Well Name: NAVAJO 26	Well Location: T29N / R14W / SEC 26 / NWSW / 36.6939875 / -108.2833905	County or Parish/State: SAN JUAN / NM
Well Number: 1	Type of Well: CONVENTIONAL GAS WELL	Allottee or Tribe Name: SHIPROCK
Lease Number: 14206032172	Unit or CA Name:	Unit or CA Number:
US Well Number: 3004530099	Well Status: Abandoned	Operator: HILCORP ENERGY COMPANY

Type of Submission: Subsequent Report Type of Action: Plug and Abandonment

NAVAJO 26 1

PLUG AND ABANDONMENT

Current Schematic - Version 3

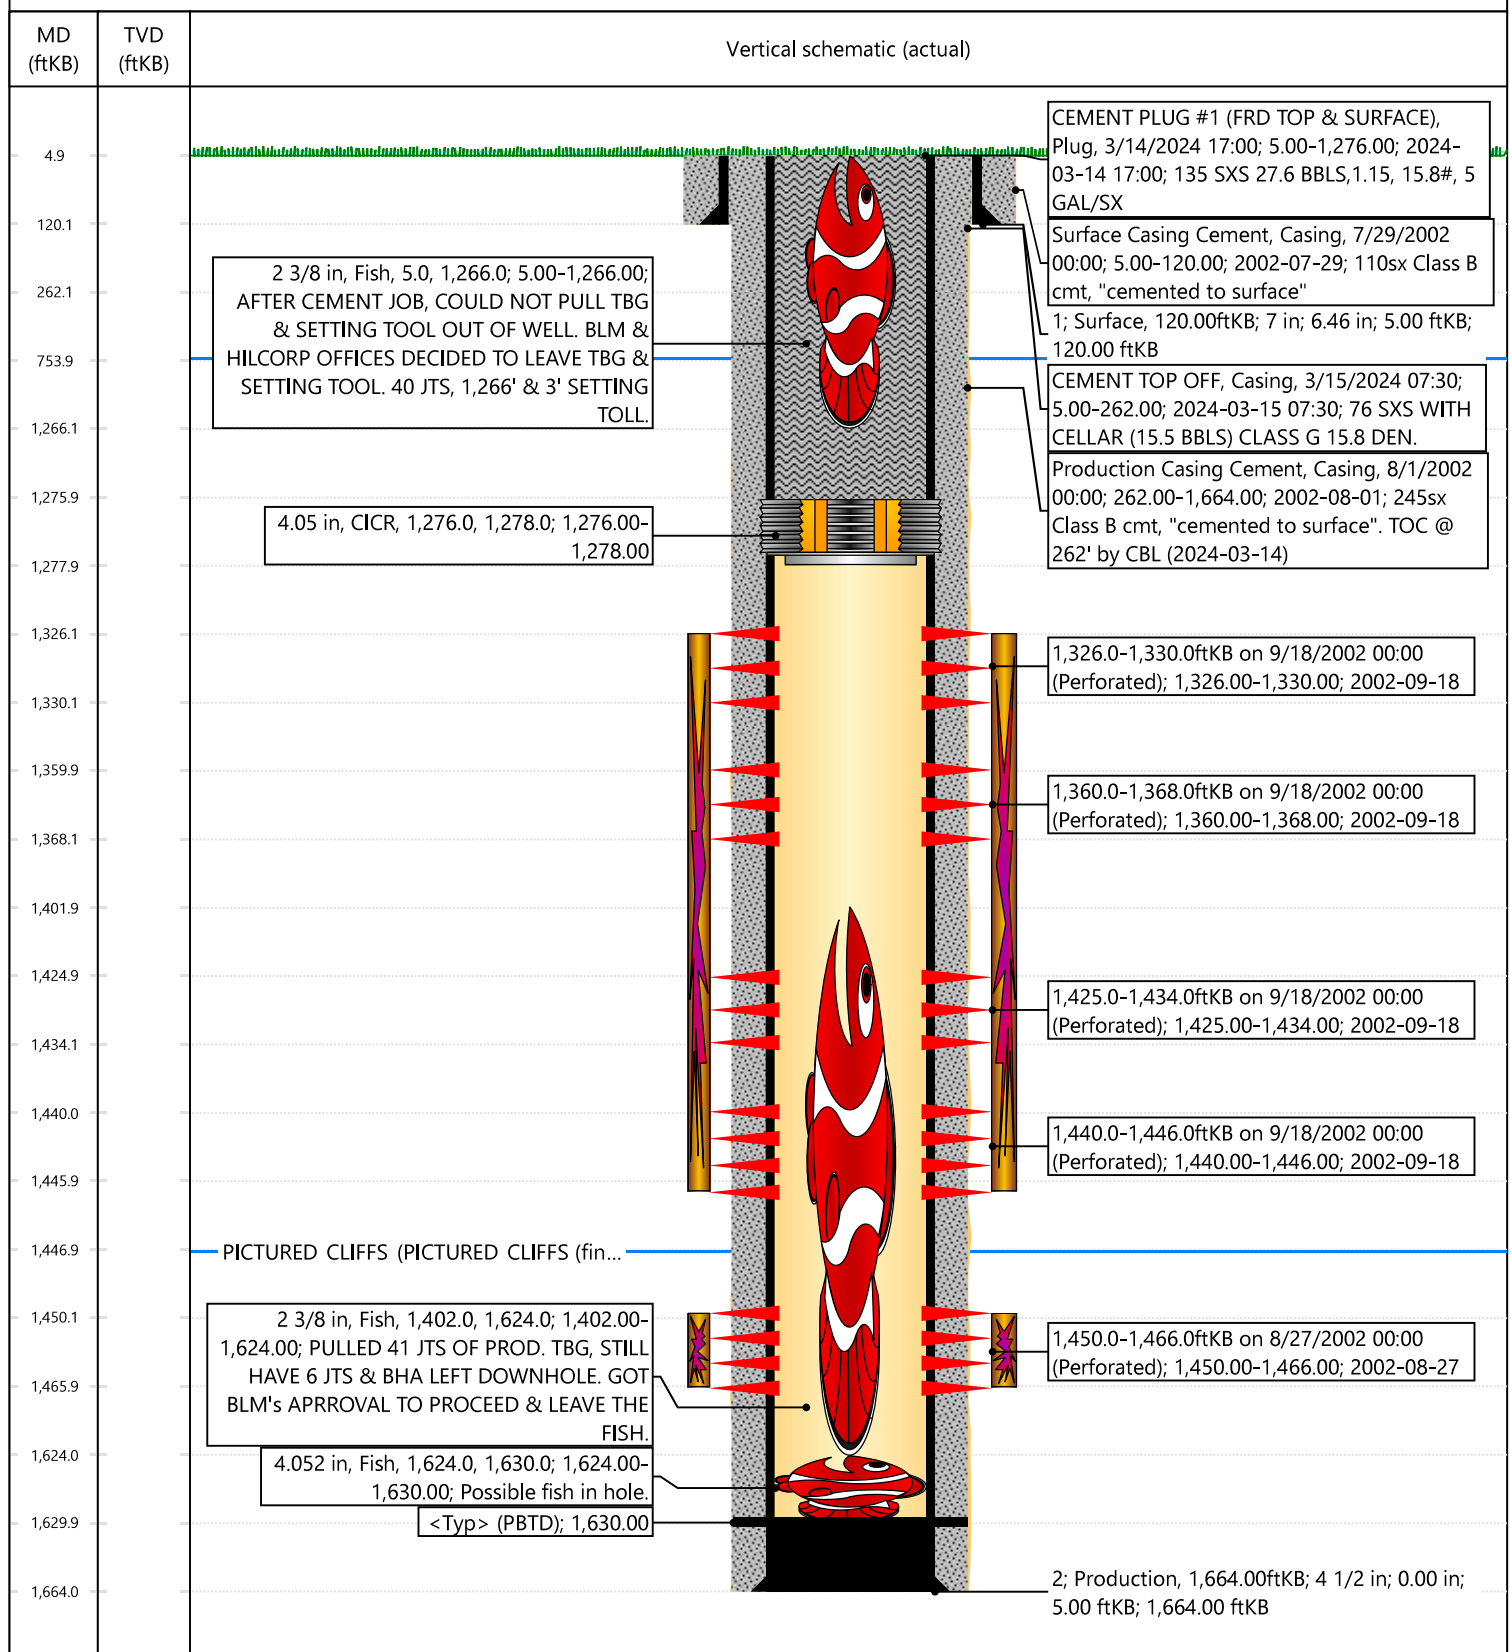
Created By	Condition	Condition Date
mkuehling	Approved for record - well plugged 3/15/2024 - No cement around bottom fish - pc open	3/29/2024
